Addendum to RFP SMART Bus Purchase Project (original RFP issue date: March 16, 2023)

A total of five requests for change, clarification, or approved equals were received. Agency responses are detailed below, bidders identifying information has been redacted.

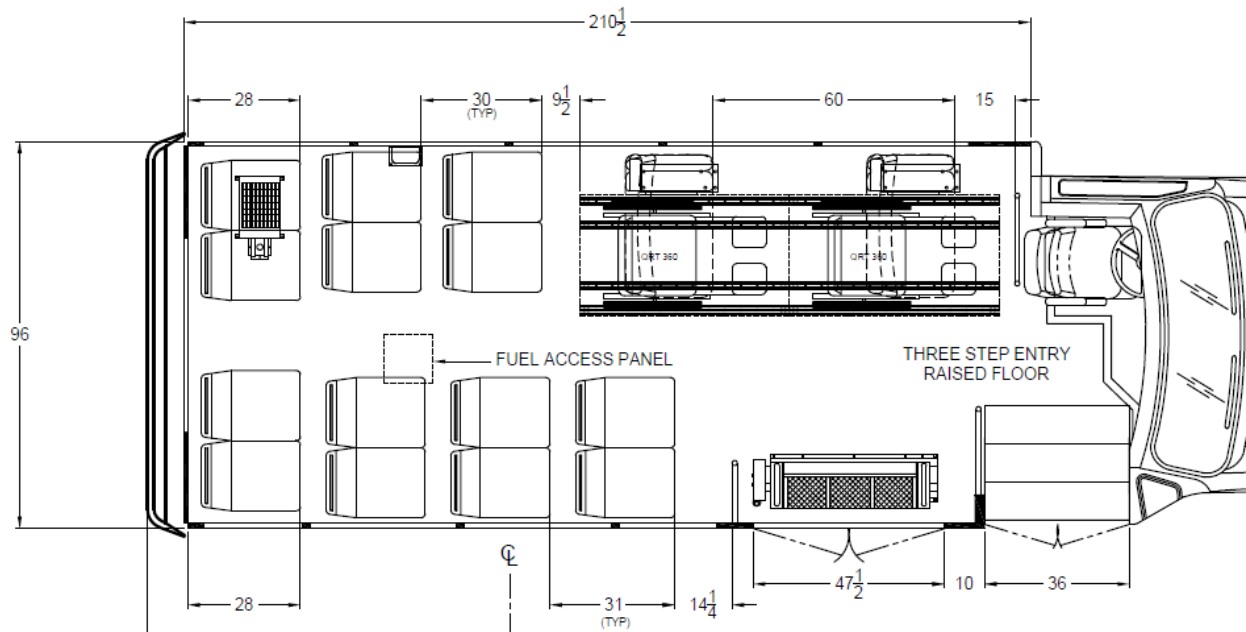
> A factory Pre-Build Weight Analysis shows that a bus built to required specifications will be overweight. The Ford E-450 chassis has a GVWR of 14,500-lbs (9,600-lbs on the rear axle). The analysis shows that the weight on the rear axle would exceed maximum by approximately 400-lbs. This is largely due to the added weight of the CNG fuel system components. Understanding that the CNG conversion must be included, it is proposed that SMART accept a reduction in passenger capacity from 21 to 18 (floorplan example attached). This would resolve pre-build weight concerns, providing a deliverable* vehicle that meets all other RFQ specifications.

Will SMART consider a proposal for an 18 passenger vehicle, meeting all other RFQ specifications?

Agency action: () Approved () Denied
 Neither specifically approved or denied.

Agency response: Although a 21 passenger vehicle is desired, the City may consider an 18 passenger vehicle, this is a "best value" procurement, and any proposed vehicles will be scored as described in the RFP. Note that "product design and performance" is part of the scoring criteria. The floorplan example submitted with this request is not acceptable to the City. We can work with bidders to adjust floorplans.
